Technical Service Bulletin (TSB)
Umbrella Valve Seal Missing From Cylinder Head Cover

REFERENCE:	TSB: 09-023-26 GROUP: 09 - Engine	Date:	September 25, 2026	REVISION:	09-020-26 09-017-26 REV A
VEHICLES AFFECTED:	2026 - 2027 (WL) Jeep Grand Cherokee / Grand Cherokee L This bulletin applies to vehicles built on or before **August 21, 2026 (MDH 0811XX)** equipped with a 2.0L Hurricane 4 Turbo W/ESS (Sales Code EC7).			MARKET APPLICABILITY: ☒ NA☒ MEA ☒ EE☒ IAP ☒ SA☐ CH NOTE: This bulletin applies to North and South America, Enlarged Europe, Middle East & Africa, and India & Asia Pacific markets.	
CUSTOMER SYMPTOM:	Vehicle may exhibit a MIL-ON. Upon inspection the technician may find that one or more of the following Diagnostic Trouble Codes (DTCs) have set: • P0300-00 - Random/Multiple Cylinder Misfire Detected. • P0301-00 - Cylinder 1 Misfire. • P0302-00 - Cylinder 2 Misfire. • P0303-00 - Cylinder 3 Misfire. • P0304-00 - Cylinder 4 Misfire.				
CAUSE:	Cover Cylinder Head Umbrella valve seal missing

Fig. 4
****Umbrella Seals - Present and Missing****

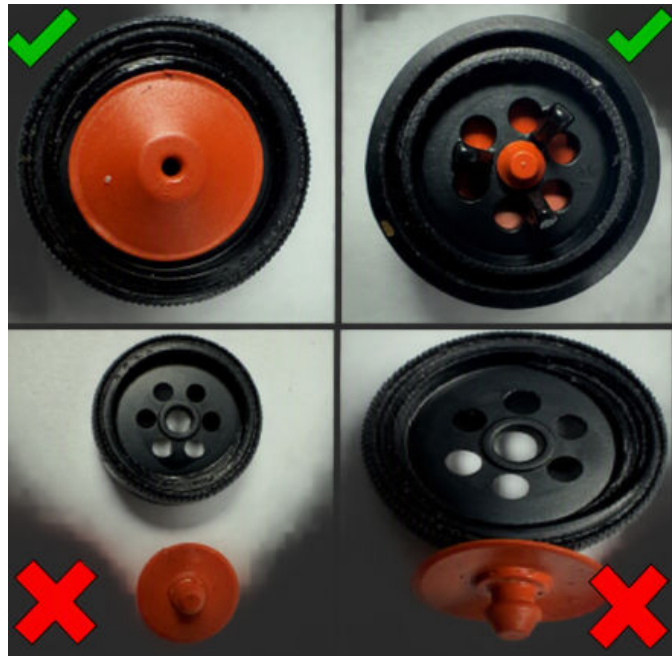
This bulletin supersedes Technical Service Bulletin (TSB) 09-020-26, date of issue August 20, 2026, and 09-017-26 REV A, date of issue August 19, 2026 which should be removed from your files. All revisions are highlighted with ****asterisks**** and includes an updated LOP time, build date, new RSU number, Repair Procedure note and Repair Procedure graphic.

2. **With the PCV valve removed**, insert a borescope into the PCV valve opening [Fig. 3](#) to inspect if the umbrella valve is missing or present [Fig. 4](#) [Fig. 5](#) [Fig. 6](#).

3. Is the umbrella valve seal missing [Fig. 4](#)?
 - YES>>> Replace the cylinder head cover assembly. Refer to the detailed service procedures available in DealerCONNECT/Service Library under: Service Info> 09 - Engine, 2.0L / Cylinder Head / Cover(s), Cylinder Head / Removal and Installation and then proceed to [Step 4](#).
 - NO>>> This bulletin has been completed. Use Inspection LOP (09-35-20-98) to close the active RSU.
4. Ensure that the engine oil level is to proper specification.
5. Using wiTECH, perform the PCM Reset ECU routine. Navigate to **Guided Diagnostics > Reset ECU**, select **PCM**, and follow the on-screen instructions to complete the procedure.
6. Clear DTCs.
